REMARKS / ARGUMENTS

Application No. 10/679,677  
Reply to Office Action of Aug 5, 2004  
Annotated Sheet Showing Changes

FIG. 1

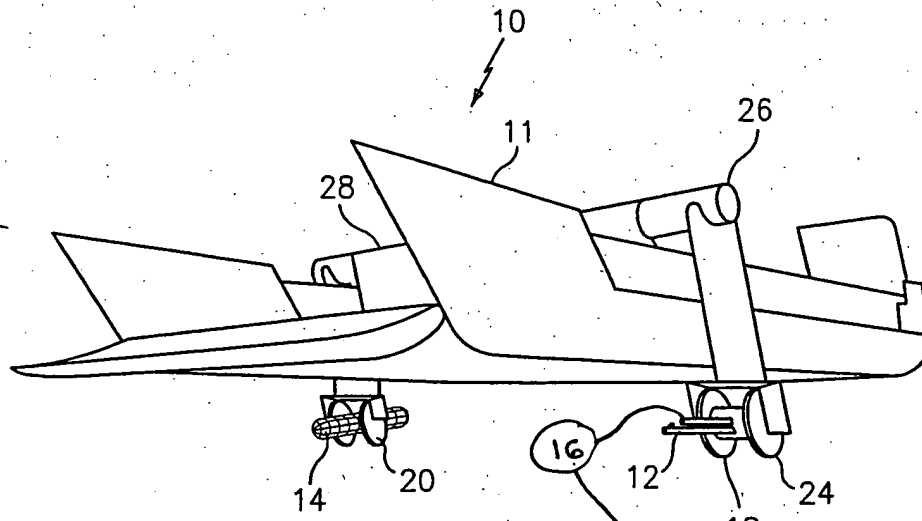
This Office Action is objected to the drawings because numerical indicator 16 (see page 6, line 15) is not illustrated. Corrected drawing sheets are required in reply to the Office action to abandonment of the application. Any amended replacement drawing sheet should include all of the figures appearing on the immediate prior version of the sheet, even if only one figure is being amended. The figure or figure number of an amended drawing should not be labeled as "amended." If a drawing figure is to be canceled, the appropriated figure must be removed from the replacement sheet, and where necessary, the remaining figures must be renumbered and appropriate changes made to the brief description of the several views of the drawings for consistency. Additional replacement sheets may be necessary to show the renumbering of the remaining figures. The replacement sheet(s) should be labeled "Replacement Sheet" in the header (as per 37 CFR 1.84(c)) so as not to obstruct any portion of the drawing figures. If the changes are not accepted by the Examiner, the applicant will be notified and informed of

Element 16  
added

In the Office Action, the drawings were objected to because numerical indicator "16" was not illustrated. In response, the drawing has been amended to identify the originally-shown barrels of the gun 12 as item no. 16. As such, the objection of the Office Action is resolved.

The attached sheet of drawings includes changes to Fig. 1. This sheet, which includes Fig. 1-2, replaces the original sheet including Fig. 1-2. In Figure 1, previously omitted element 16 has been added.
